RE: Docket No. 50-609, Northwest Medical Isotopes, LLC Responses to the U.S. Nuclear Regulatory Commission Environmental Request for Additional information – Letter Dated January 25, 2017

**U.S. Nuclear Regulatory Commission
Request for Additional Information for Construction Permit Application
Regarding the Emergency Response Plan
(TAC No. MF6138)**

**Northwest Medical Isotopes, LLC
Construction Permit Application Docket No. 50-609
(Document No. NWMI-2017-RAI-001, Rev. 1, April 2017)**

NWMI-2017-RAI-001, Rev. 1
April 2017

Figure 1. Radioisotope Production Facility Complex in the Columbia Area (Replacement for Figure A-3)

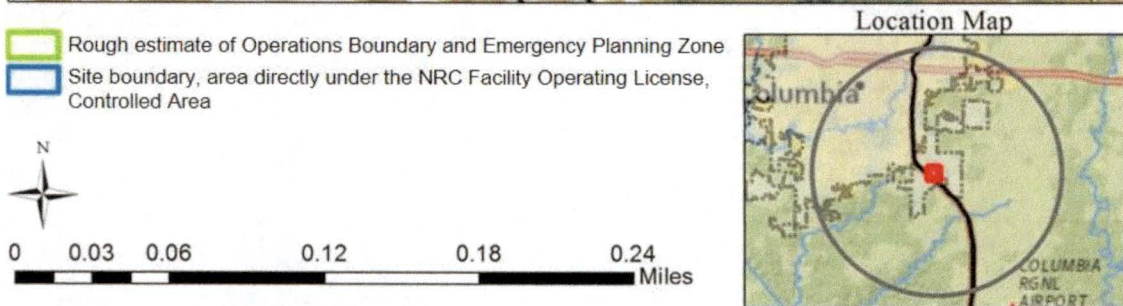
| No. | Request for additional information |
|-------------------|--|
| RAI 12A-1a | <p><i>Provide a legible figure of the facility and/or an electronic copy that could be manipulated to facilitate resolution of building names/numbers and labels, roads and parking lots, site boundaries showing fences and gates, major site features, access routes, and water bodies within approximately 1 mile of the site.</i></p> |

A legible copy of the proposed Northwest Medical Isotopes, LLC (NWMI) Radioisotope Production Facility (RPF) is provided in Figure 1. This figure will replace Figure A-3 in NWMI-2013-021, *Construction Permit Application for Radioisotope Production Facility*, Chapter 12.0, "Conduct of Operations," Appendix A, "Emergency Response Plan." In addition, Figure 2 and Figure 3 on subsequent pages provide additional detail of the RPF site (including roads, fences, gates, access routes) (Chapter 19, Figure 19-7) and water bodies within 1 kilometer (km) (1-mile [mi]) of the RPF, respectively.
